CRUISER
AIRCRAFT

No.: SB-SC-083

SERVICE BULLETIN

MODEL AFFECTED:	SportCruiser / PiperSport operating outside EASA rules
SUBJECT:	Backrest wall reinforcement
AIRCRAFT AFFECTED:	All SportCruiser / Piper Sport aircraft
COMPLIANCE:	When the backrest wall crack or bend or buckling occurs

Fig. 1: Backrest wall reinforcement

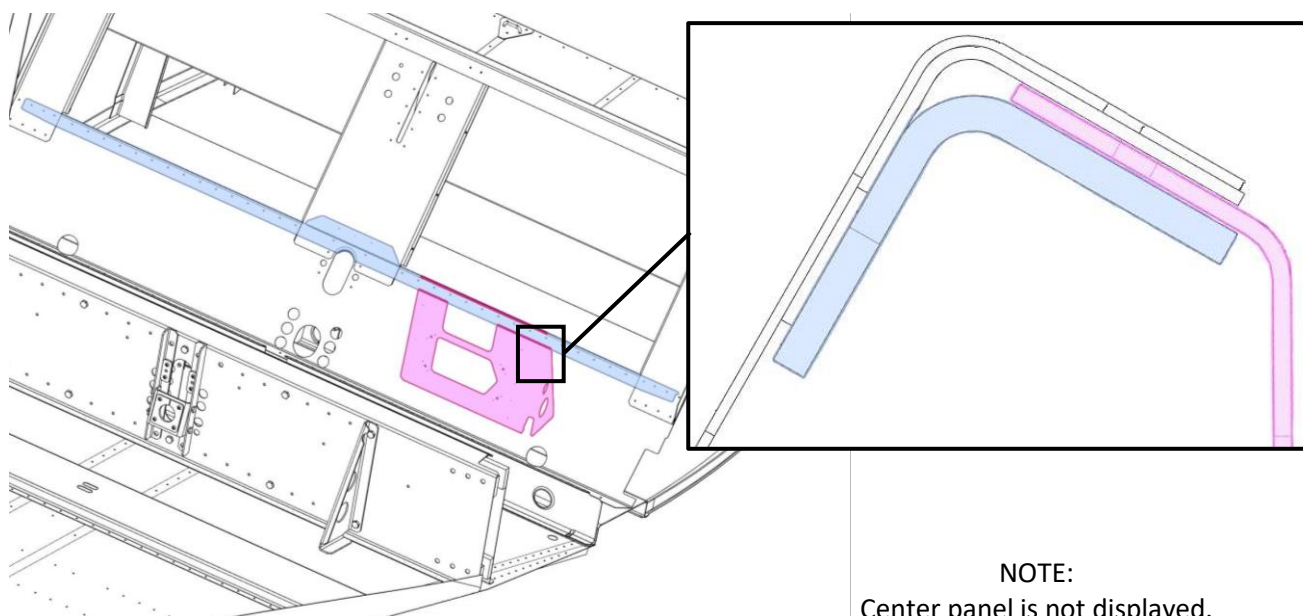
- 1) Move the aircraft to a place suitable to perform the work.
- 2) Fold down the backrests of both seats.
- 3) Unscrew the screws holding the backrests. Remove the backrests and seats.
- 4) Drill out the rivet nuts.
- 5) Drill out the rivets from the edge (blue area). See Fig. 1. Do not drill out the rivets from the center section between seats.
- 6) Straighten the bent parts.
- 7) If there are cracks at the bend, drill the end of the crack.
- 8) It is necessary to drill 2 x \varnothing 6 mm (0,24 in) holes in the lower reinforcement (001) to pass the riveted rivets. See Fig. 2. Measure the exact position on the aircraft.

- 9) Attach the upper (002) and lower (001) reinforcement. Pay close attention to the attachment area of the autopilot bracket (pink area). See Fig. 1.
- 10) Rivets are marked on the Fig. 3.
- 11) Drill \varnothing 4,2 mm (0,16 in) holes for rivets (003).

Fig. 3: Location of reinforcements (local cut)

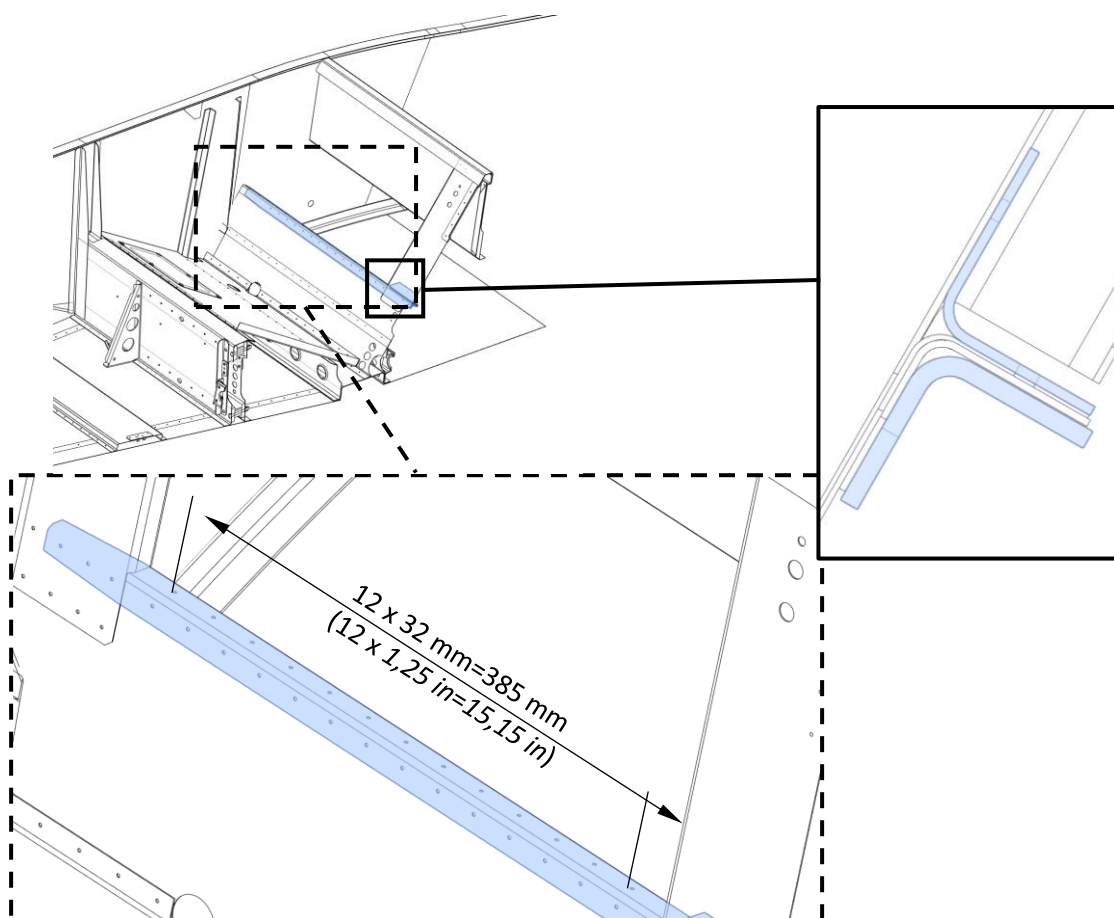
- 12) From the front side is necessary to drill the added reinforcement only, there are holes in the original parts. The new holes must be coaxial with the original holes.
- 13) From the upper side is necessary to drill added reinforcement and the original parts.
- 14) Rivet the reinforcements.
- 15) Drill $\varnothing 6$ mm (0,24 in) holes for rivet nuts (004). It is necessary to drill only the added reinforcement, there are holes in the original parts. The new holes must be coaxial with the original holes.
- 16) Rivet the rivet nuts.
